### NORTH SYDNEY COUNCIL REPORTS

# NSLPP MEETING HELD ON 05/03/2025 SECTION 4.55 APPLICATION REPORT

ADDRESS/WARD: 184 Kurraba Road, Kurraba Point

**APPLICATION NO**: DA 266/23/3

### **Tree Retention**

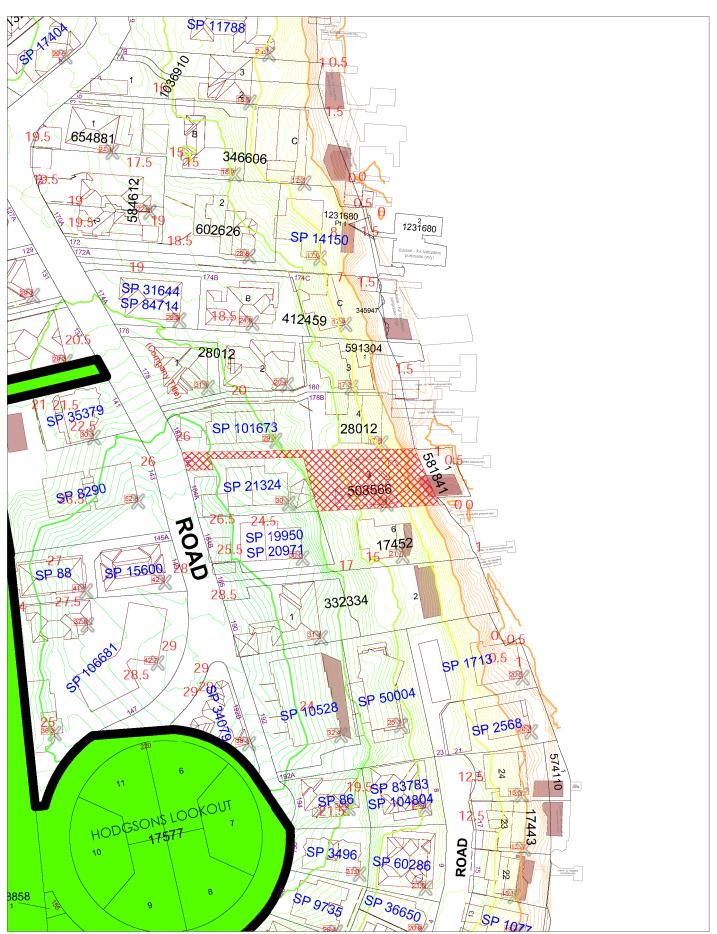
1. The Proposed Site Plan shows Trees T2, T3 & T5 to be removed (dashed line). The endorsed Aboricultural Impact Assessment identifies these trees for retention. Clarification is required as to whether these trees are to be retained/removed. If the trees are now proposed to be removed, an amended Aboricultural Impact Assessment and amended Landscape Plan are to be provided.

Insufficient information has been provided in relation to tree retention/removal relative to the original approval. In particular, clarification is sought as to whether Tree 5 ('T5') an 'Acer palmatum' Japanese Maple is proposed to be removed under the modification. Trees are shown dashed for removal that were not approved.

C26. Tree T5 an 'Acer palmatum' Japanese Maple is to be retained.

While the Proposed Site Plan erroneously shows T5 with a dashed line, this tree is to be retained. Notably, all other architectural schedules submitted accurately depict T5 with a hard line. Please find attached a corrected Proposed Site Plan showing T5 with a hard line.

No changes are being made to the existing consent regarding tree removal or retention. While the site plan (high-level view) erroneously depicts T5 as dashed, the floor plans correctly depict T5 with a hard line denoting that the tree is to be retained.

There is no change to the approved landscape plan and existing consent conditions relating to trees. Both documents clearly show the retention of tree T5. In any case, a revised Proposed Site Plan has been provided further clarifying that tree T5 is to be retained.

ELEVATIONS - PROPOSED S4.55 - West Elevation

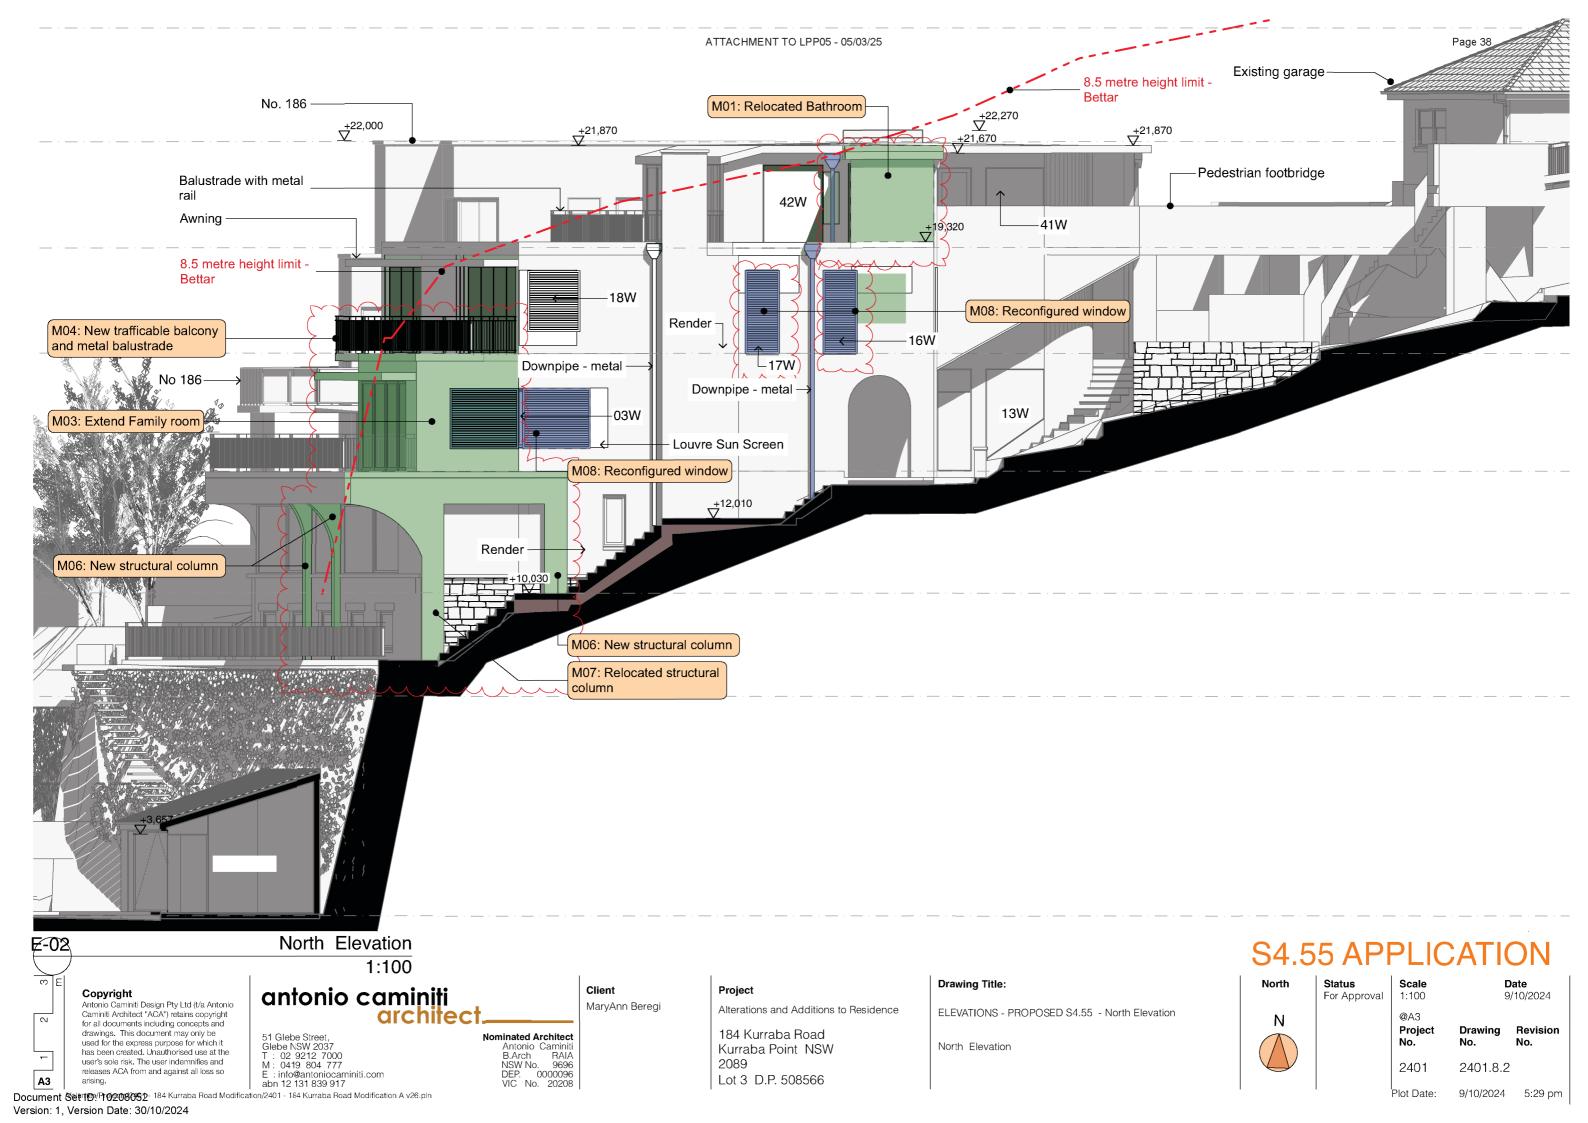
6. The relocated bathroom on the second floor level will result in the addition of a blank wall along the front western building elevation which will impact the streetscape. Details of the wall materiality and colours and how this addition integrates with the approved front elevation are to be provided. The integration of the addition is to have regard to the controls at Part B Sections 1.4.8 (Built Form Character) and 1.4.12 (Colours and Materials) of the North Sydney Development Control Plan 2013.

1.4	Quality built form				
1.4.3	Streetscape	Yes	A condition of consent has been recommended requiring an amended Western Elevation Plan to be provided, prior to the issue of a Construction Certificate, that incorporates articulation to the external western wall of the relocated bathroom, through variations in materials and colours.

PLANS - PROPOSED S4.55 - Roof Plan

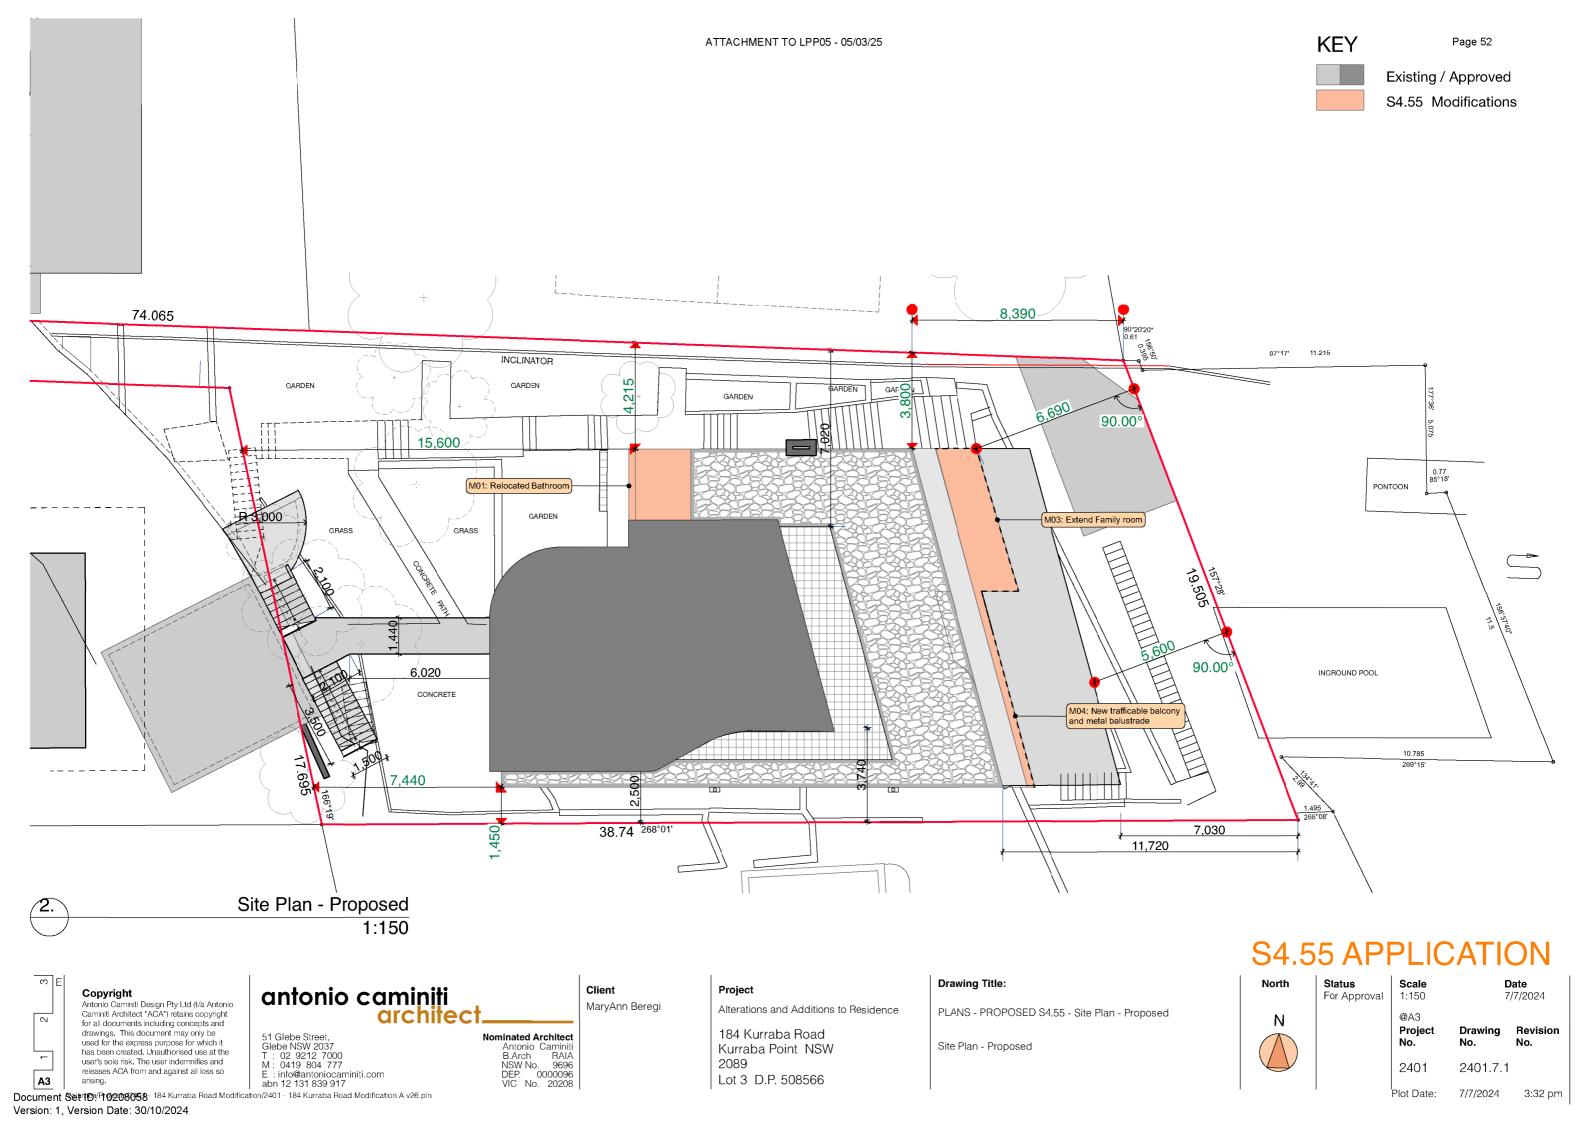
2. The endorsed Roof Level Plan approved a concrete roof. The amended Roof Level Plan denotes the roof as comprising "concrete or steel framing / metal deck roofing to engineers detail at construction certificate stage." The proposed roof materiality is to be clarified. If the approved concrete roofing is to be changed, details of the revised roof materiality and colour are to be provided in an amended materials and colours schedule.

1.4.9	Dwelling Entry	Yes	No change is proposed to the approved dwelling entry.		
1.4.10	Roofs	Acceptable	A Material Selections Plan has been provided in response to Council's request for additional information which clarifies that the roof will comprise a non-reflective Colorbond Matt Finish in Windspray.

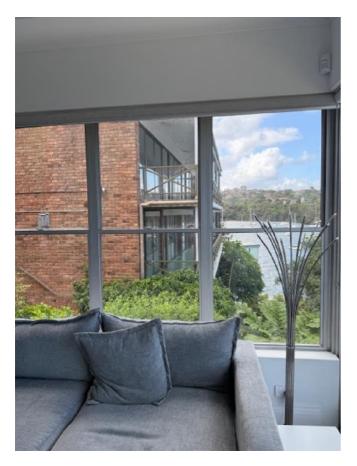
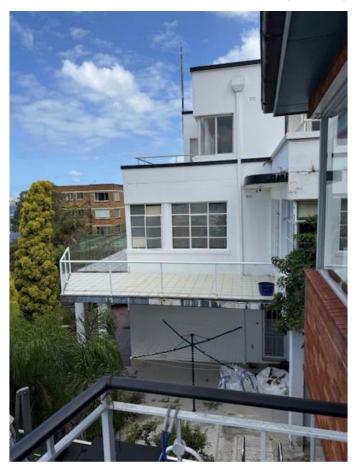
4. Privacy screens are required to be provided along the northern and southern elevations of the proposed balcony on the first floor level to mitigate privacy impacts on the adjoining properties. Amended Floor and Elevation plans are required that incorporate the screens, including details of material and colour.

There will be no privacy impacts resulting from the proposed balcony as existing and proposed windows and balconies already provide the same views across neighbouring properties. Please see photographs below demonstrating the existing circumstances:

Photo 1: View from existing level 1 bedroom to the north towards 178B Kurraba Road.

Photo 2: View from existing ground level terrace to the north towards 178B Kurraba Road.

Photo 3: View from existing ground floor living room to the north towards 178B Kurraba Road.

Photo 4: View from centre of existing ground level terrace to the north towards 178B Kurraba Road

Photo 5: View from existing first level bedroom to the south towards 186 Kurraba Road

Photo 6: View from existing first level balcony to the south towards 186 Kurraba Road

Photo 7: View from existing ground level terrace to the north towards 186 Kurraba Road
